# Access Compliance Report Public Rights-of-Way (Curb Ramps)

**Main Street:** DARMEL\_PL      **Cross Street:** DARMEL\_PL      **Location:** NW

**ADA ID:** RPRK211229134734      **Ramp Type:** Type 4 - Parallel      **Initial Pass/Fail:** Pass      **Overall Compliance:** No      **Severity Score:** 0

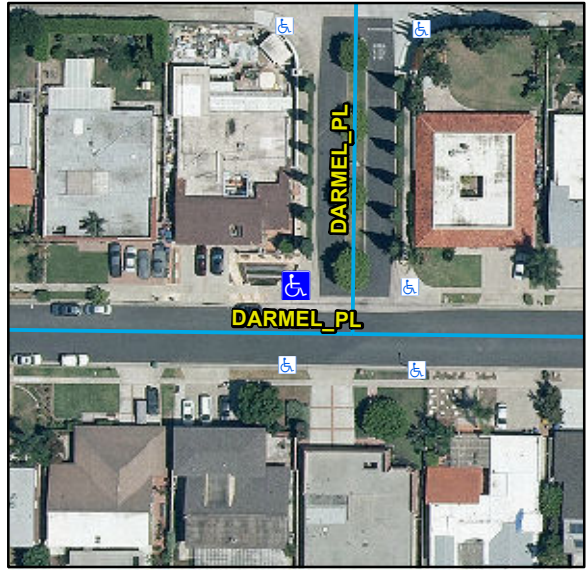
Compliance	Description	Data	Compliance	Description	Data
N/A	Ramp Length LT (in)	112	N/A	Ramp Length RT (in)	114
Yes	Ramp Width LT (in)	92	Yes	Ramp Width RT (in)	92
Yes	Ramp Run Slope LT (%)	3.2	Yes	Ramp Run Slope RT (%)	5.6
Yes	Ramp Cross Slope LT (%)	1.4	Yes	Ramp Cross Slope RT (%)	1.8
N/A	Landing Present	Yes	Yes	DWS Provided	Yes
N/A	Landing Length (in)	92	Yes	DWS Contrast	Yes
Yes	Landing Width (in)	48	Yes	DWS Length (in)	36
Yes	Landing Run Slope (%)	1.8	Yes	DWS Full Width	Yes
Yes	Landing Cross Slope (%)	0.8		DWS Offset Type	Single
N/A	Landing Movement Obstructed?	No	Yes	DWS Offset Left (in)	0
	Landing Movement Type	Curb	Yes	DWS Offset Right (in)	N/A
N/A	Landing Shared	No			
N/A	Clear Space	Yes			
N/A	Clear Space To Crosswalk (in)	48			
N/A	Marked Crosswalk 1	No	N/A	Marked Crosswalk 2	No
	Crossing 1 Direction	S		Crossing 2 Direction	E
	Marked Crosswalk 1 Width (in)	N/A		Marked Crosswalk 2 Width (in)	N/A
N/A	Ramp Inside Crosswalk 1	N/A	N/A	Ramp Inside Crosswalk 2	N/A

Crossing 1 Slope (%)	2.2		Crossing 2 Slope (%)	1.1
	Crossing 1 Cross Slope (%)	0.6		Crossing 2 Cross Slope (%)	2
Yes	Gutter Ponding	No	Yes	Curb Slope	0.9
Yes	Gutter Lip Height (in)	0		Road Run Slope (%)	0.6
Yes	Gutter Run Slope (%)	1.4		Road Cross Slope (%)	1.3
Yes	Gutter Cross Slope (%)	0.8	No	Perpendicular Joint Present	No
Yes	Overall Surface Condition	Acceptable			
	Cross Gutter Present?	Yes		Spandrel Present?	Yes
	Replace Cross Gutter?	No		Replace Spandrel?	No

**Possible Solutions:**  
**Remove & Replace Curb Ramp With Two New Directional Ramps or Equivalent.**

**OC Std/PROW:**  
**R204.3, STD 1115**
